**FINAL STATEMENT OF REASONS
FOR
PROPOSED BUILDING STANDARDS
OF THE
OFFICE OF THE STATE FIRE MARSHAL**

**REGARDING THE 2016 CALIFORNIA RESIDENTIAL CODE
CALIFORNIA CODE OF REGULATIONS, TITLE 24, PART 2.5**

~~FIGURE 11.2.3.2.3.1 Design Area Reduction for Quick Response Sprinklers~~

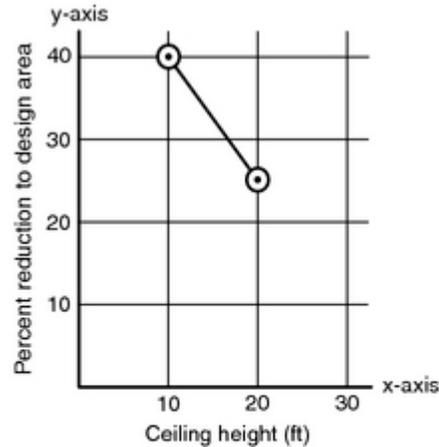
Note: $y = \frac{-3x}{2} + 55$

For ceiling height ≥ 10 ft and ≤ 20 ft, $y = \frac{-3x}{2} + 55$

For ceiling height < 10 ft, $y = 40$

For ceiling height > 20 , $y = 0$
